**SUBJECT:** Transmittal of Revised Responses to AP1000 DSER Open Items

# AP1000 DESIGN CERTIFICATION REVIEW

DSER Open Item Number: 21.5-1 Item ADS4 K Sensitivity

Original RAI Number(s): 440.164

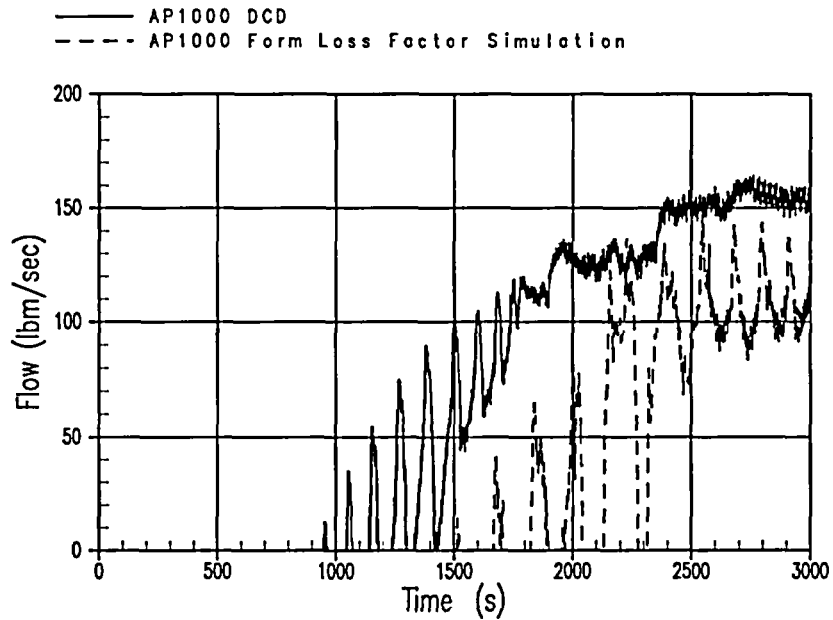
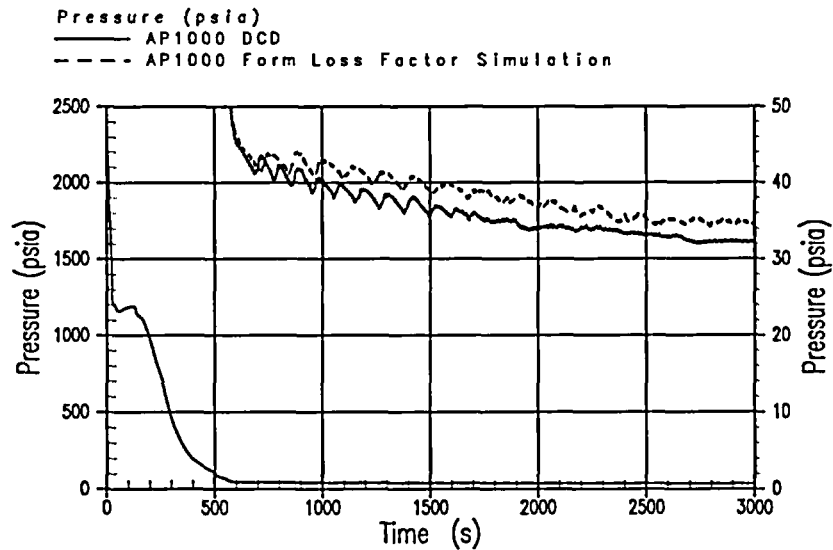
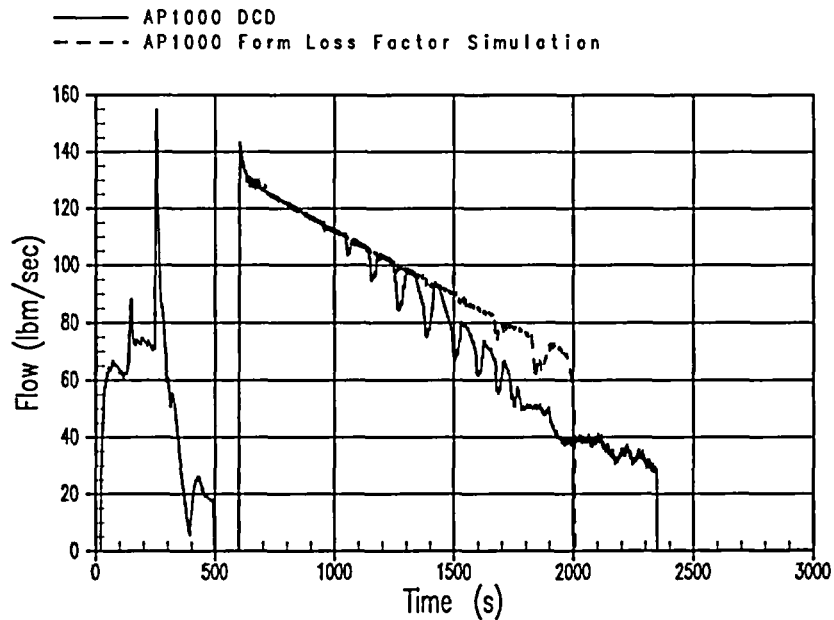
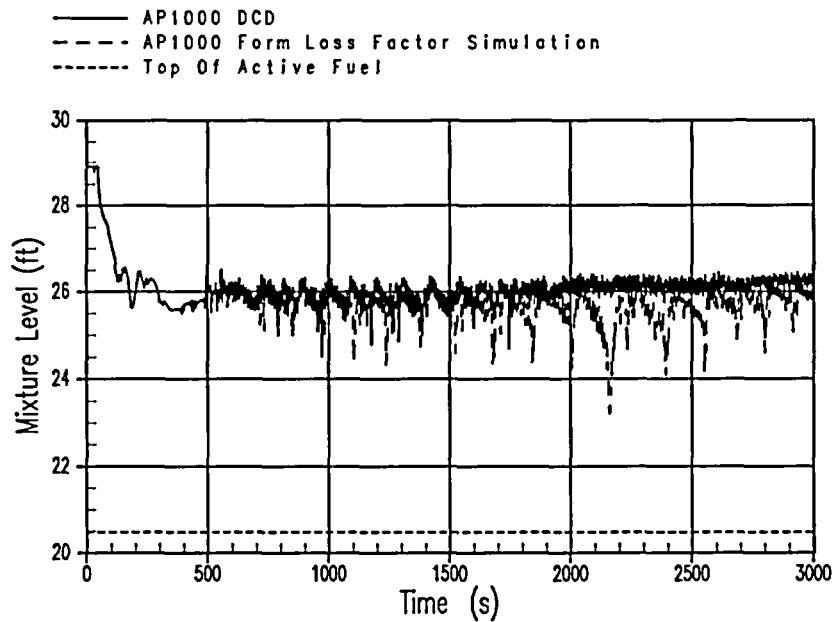
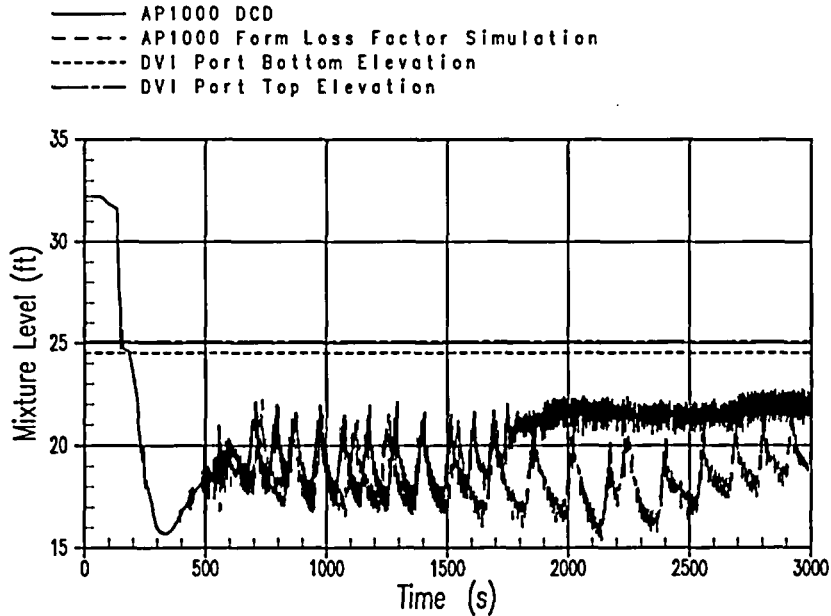
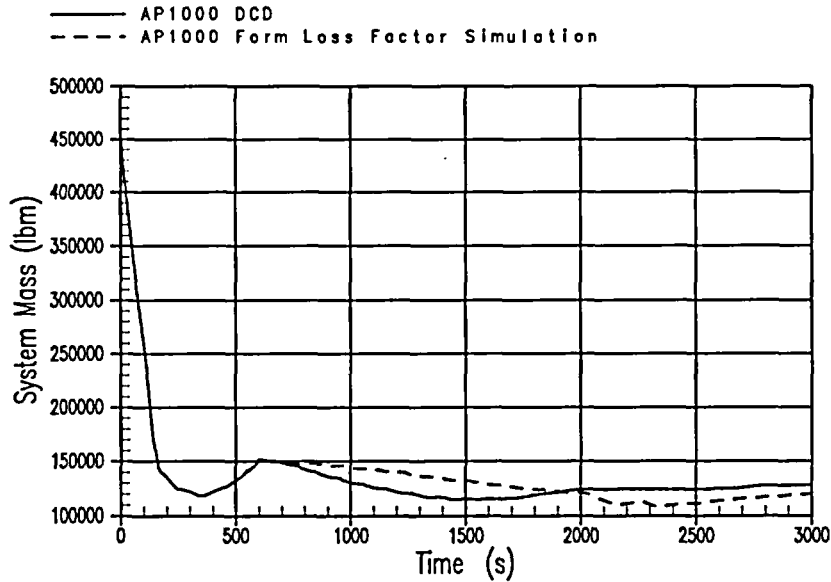
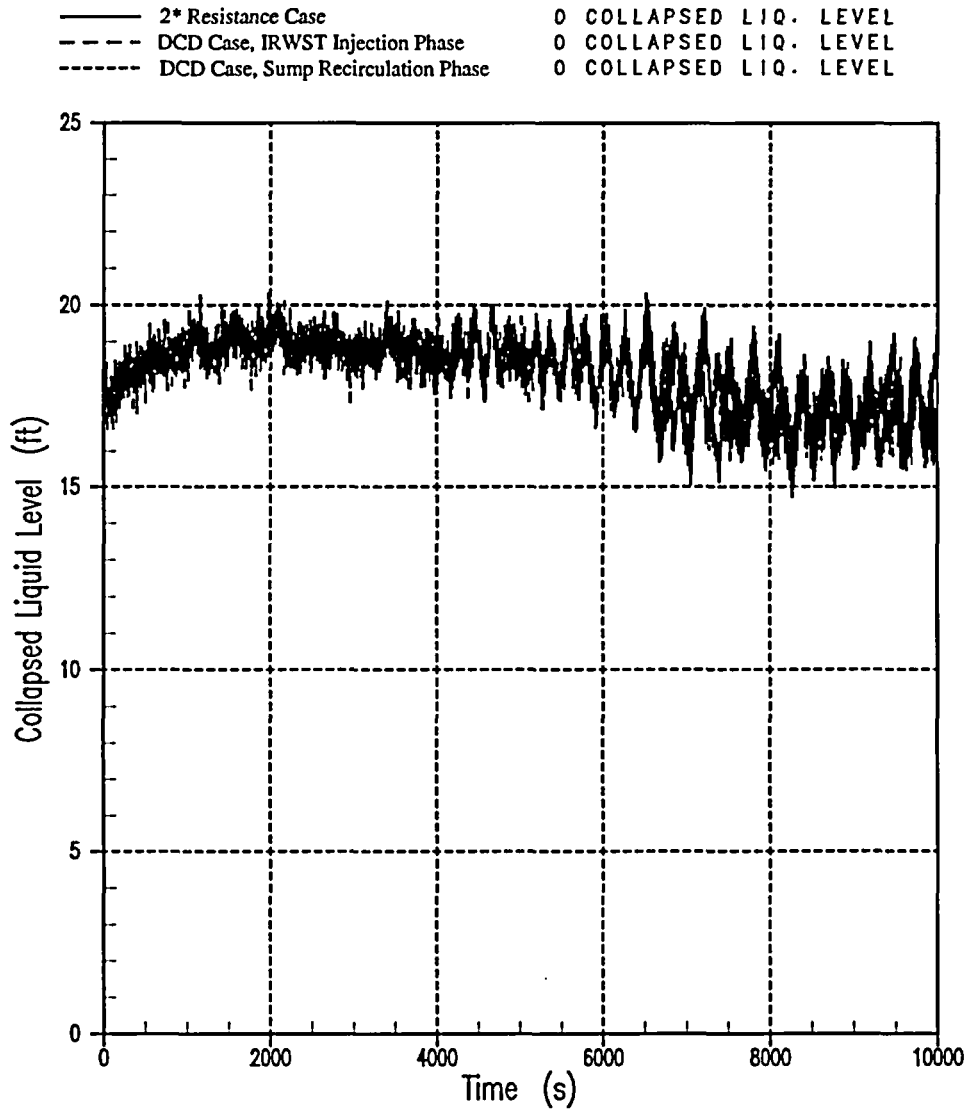
In the October 2, 2003, NRC / Westinghouse meeting on AP1000 thermal/hydraulic open items the NRC requested NOTRUMP (SBLOCA) and WCOBRA/TRAC (LTC) sensitivity analyses to the form loss factors used in modeling the AP1000 ADS4 flow paths.

The NOTRUMP DEDVI, with the adjusted ADS-4 flow paths, simulation was performed in the same fashion as the DCD cases. The event times for this transient are shown in Table-1. The transient results are shown in Figures 1 through 7 for the base DCD case and for the

sensitivity case. The results indicate that the increased ADS4 resistance slows the system depressurization after ADS4 opens and delays the start of IRWST injection. The IRWST is delayed until after the intact CMT has drained. The inner vessel mixture level reaches its minimum just prior to sustained IRWST injection for the sensitivity case but is still well above the top of the core.

The base DCD analysis includes conservatism in the ADS4 form losses in the method used to determine these losses for the ADS4 flow paths. This sensitivity analysis indicates that the DCD analysis is not highly sensitive to the ADS4 flow path form losses.
